**KAWARTHA PINE RIDGE DISTRICT SCHOOL BOARD
PUR24-070-ITT
Dr M.S. Hawkins Public School Classroom Upgrades**

ADDENDUM NO. 3

Add (2): Addendum No. 2. Project No. 23A117, prepared by CMV Group architects, dated April 16, 2024, (7 pages)

DATE April 16, 2024 ADDENDUM No 2
PROJECT Dr M.S. Hawkins Sr Public School Classroom Renovations PROJECT No 23A117

1 SECOND FLOOR PLAN
A200 SCALE: 1:200

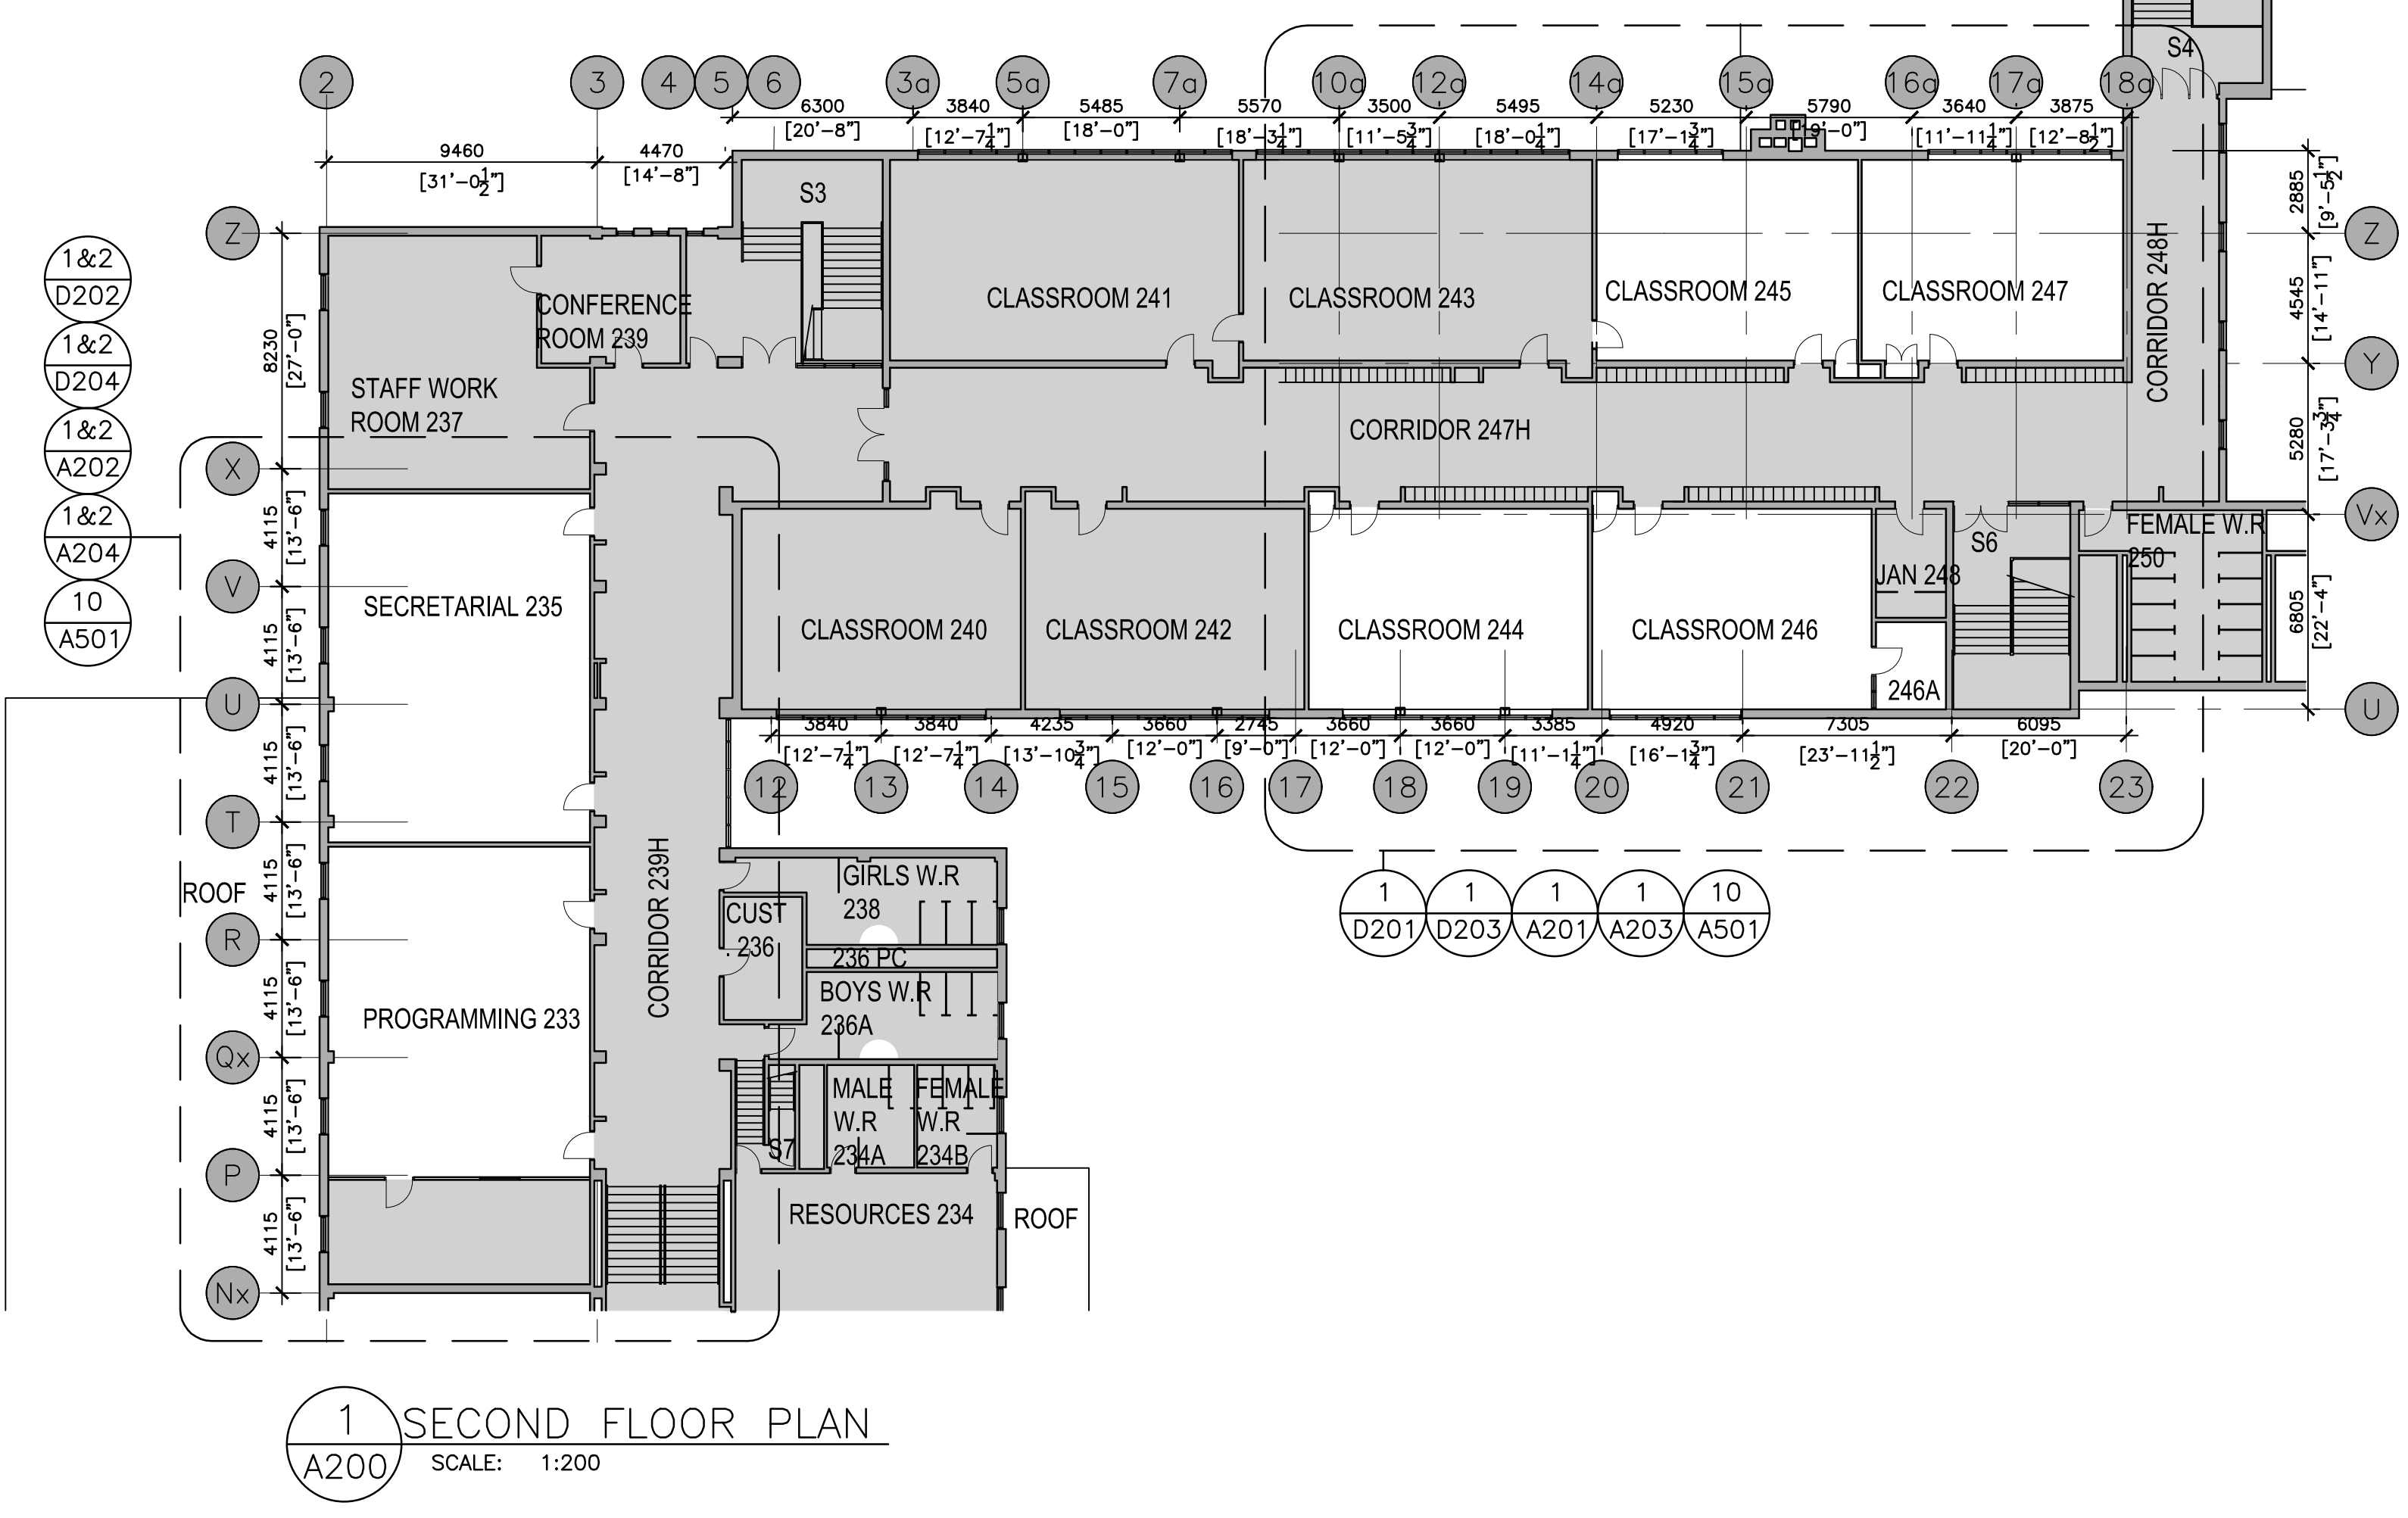
Question 1: Note 2A of A200 – This item mentioned remove existing metal caps and embedded pipes. But mechanical drawing does not indicate removal of existing metal caps & embedded pipes. Please more detail of how slab is repair at these locations.

Question 4: Unit ventilators are to be removed to install flooring underneath. But this requirement is not mentioned in mechanical drawing.

Question 5: Cover of existing radiators are to be removed to install new flooring underneath. But this requirement is not mentioned in mechanical drawing.

Question 7: Who will remove and reinstall WI-FI APS?

Question 8: Demolition Note 20 of drawing A200 – Provide location & typical section of 16mm drywall enclosure on 92mm metal stud if required.

Question 10: Note 25 of drawing A200 – We are not able to decide which areas need self-leveling underlayment, until we remove the existing flooring. We therefore suggest to include self-levelling underlayment to Cash Allowance or provide tentative quantity of self-levelling underlayment area for us to include in bid price.

Question 11: Note 26 of drawing A200 – Which windows painting and caulking? Please confirm that painting is required window frame interior side only.

Note 2A on drawing A200, this is not a mechanical item. Remove existing metal protrusions in floors, fill voids with concrete and underlayment. See project manual section 03 53 00.

Note 9 on drawing A200, note has been revised to indicate that unit ventilators are not being removed and reinstalled. New flooring is to butt up against unit ventilator enclosure.

Note 23 on drawing A200, existing radiator covers are to remain and be painted refer to note. Existing radiator covers do not go down to the floor; therefore, installation of flooring underneath of radiators will not be a problem.

WIFI APs see note 19 on drawing A200.

Note 20 on drawing A200, new drywall enclosure is only required if removal of existing millwork exposes any openings and holes in the existing exterior wall.

- Proceed as specified in the Project Manual (Issued for Bid) section 03 53 00 Cementitious Self-Levelling Underlayment.
- Cash allowance will not be assigned to this scope of work.

Note 26 on drawing A200, room 246A all window frames to be painted both sides. Room 233, window frame in the interior partition to be painted both sides as per the note on floor plan.

- 2A. GC TO REMOVE EXISTING METAL CAP AND EMBEDDED PIPE IN ORDER TO PROVIDE FLUSH SURFACE FOR NEW FLOORING. TYPICAL OF 36 LOCATIONS. PATCH AND REPAIR CONCRETE SLAB WITH SELF LEVELLING COMPOUND. SEE SPECIFICATIONS. MAKE CONCRETE SLAB READY FOR NEW FLOORING AS PER MANUFACTURERS REQUIREMENTS. TYPICAL.

9. EXISTING UNIT VENTILATORS TO REMAIN, AND TO BE CLEANED PRIOR TO PAINTING. EXISTING FLOORING AND WALL BASE TO BE REMOVED AROUND UNIT VENTILATORS AND DOOR THRESHOLDS. TYP. REPAIR EXTG UNIT VENTILATORS ENCLOSURE.

20. REMOVE EXTG WALL/TRIM AT LOCATION OF EXTG UNIT VENTILATORS. PROVIDE CLEAR SPACE FOR INSTALLATION OF NEW MILLWORK WITH NEW AIR GRILLES. CLOSE ADJACENT OPENINGS & HOLES. INSTALL 16MM DRYWALL ENCLOSURE ON 92MM ST STUD IF REQ'D.

21. EXISTING DUCTWORK AND ACCESS PANELS TO REMAIN. REFER TO MECHANICAL DRAWING.
22. EXISTING GLASS AND HOLLOW METAL FRAME TO REMAIN.
23. EXISTING RADIATOR TO REMAIN, AND TO BE CLEANED PRIOR TO PAINTING. EXISTING FLOORING AND WALL BASE TO BE REMOVED UNDER AND AROUND RADIATOR AND TO DOOR THRESHOLDS. TYP. REPAIR EXTG RADIATOR ENCLOSURE.

26. EXISTING WINDOW FRAME TO REMAIN. PATCH, SAND REPAIR, AND PAINT ALL FRAMES REMOVE DIRT AND DEBRIS FROM THE WINDOW FRAME AND GLASSES. WASH, CLEAN, AND REMOVE OXIDATION FROM FRAME. REMOVE EXTG CAULKING, RE-CAULK AROUND FRAMES. MAKE GOOD FRAMES SO THAT GLASS & FRAME LOOK AS NEW.

Drawing Title: CLASSROOMS 244 TO 247 MECHANICAL NEW			
Drawn By: CAD	Checked By: AF	Date Checked:	Project No.
Date Plotted: Apr 16, 2024 - 4:08pm	Scale: 1:50	Revision No.:	
M1-201

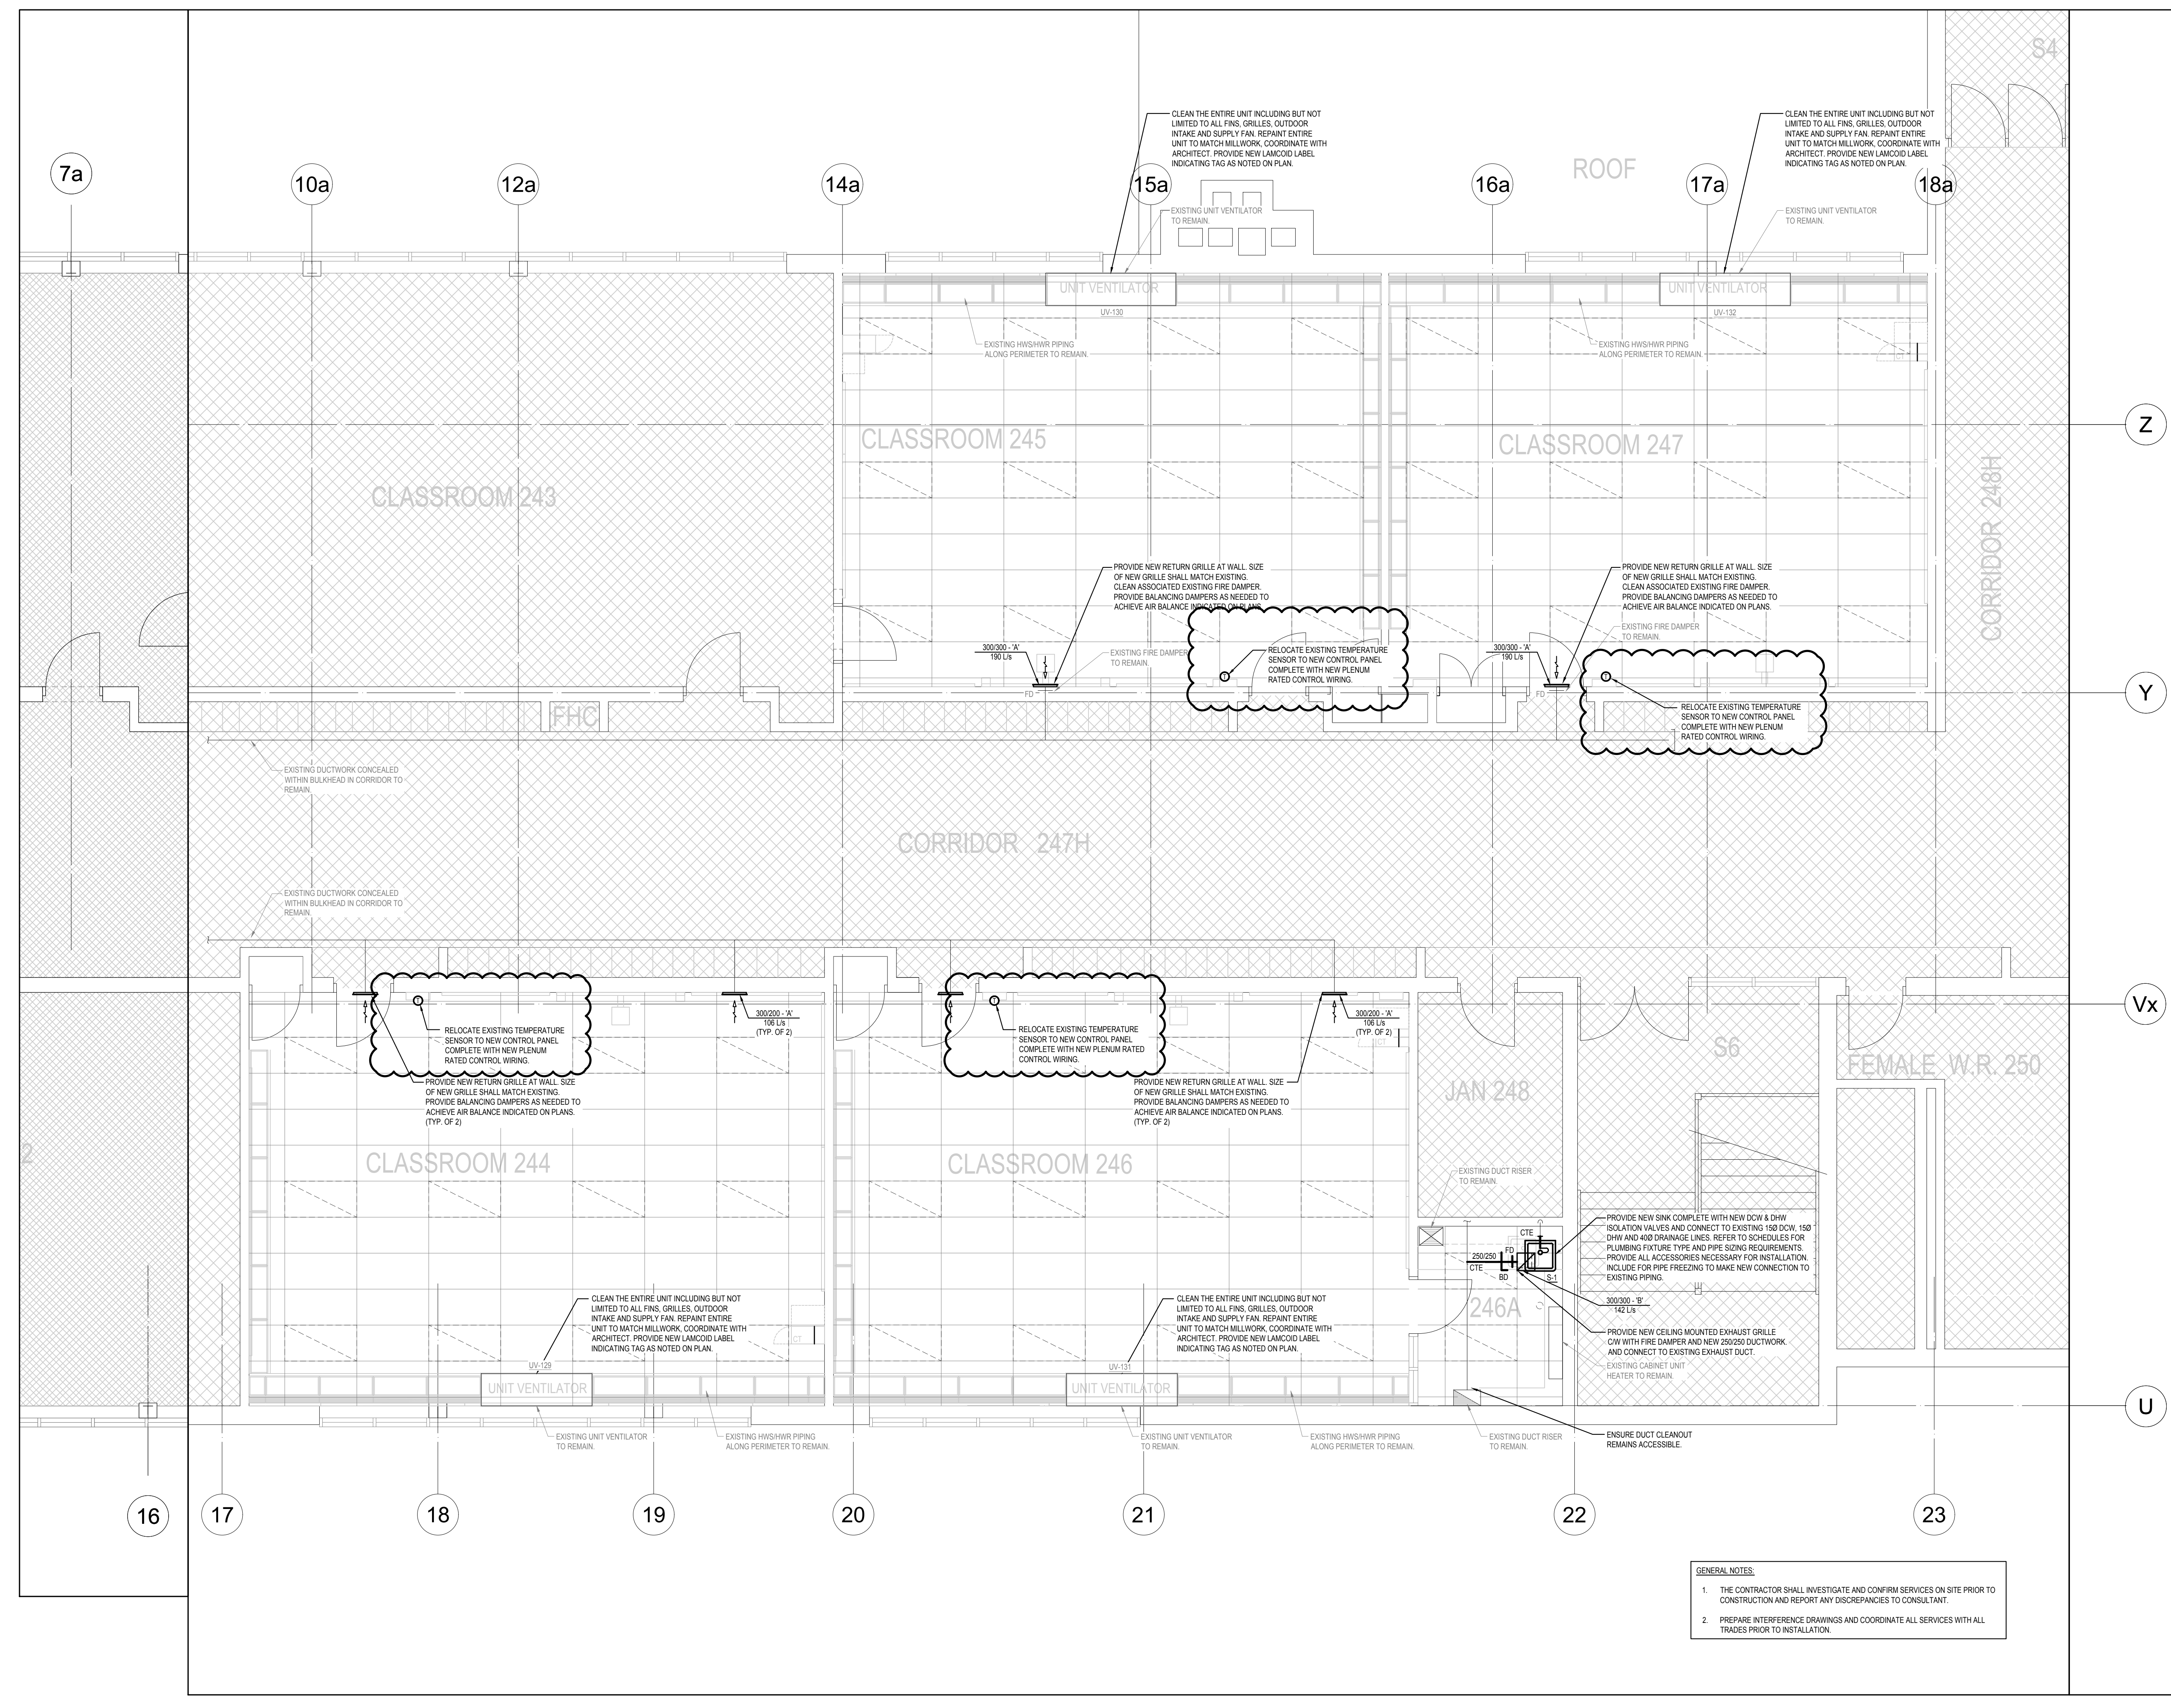
- 2.1 Drawing No. M1-101
 - .1 Revised drawing to illustrate removal of four (4) existing room temperature sensors.
- 2.2 Drawing No. M1-202
 - .1 Updated drawing to illustrate the relocation of four (4) existing room temperature sensors,
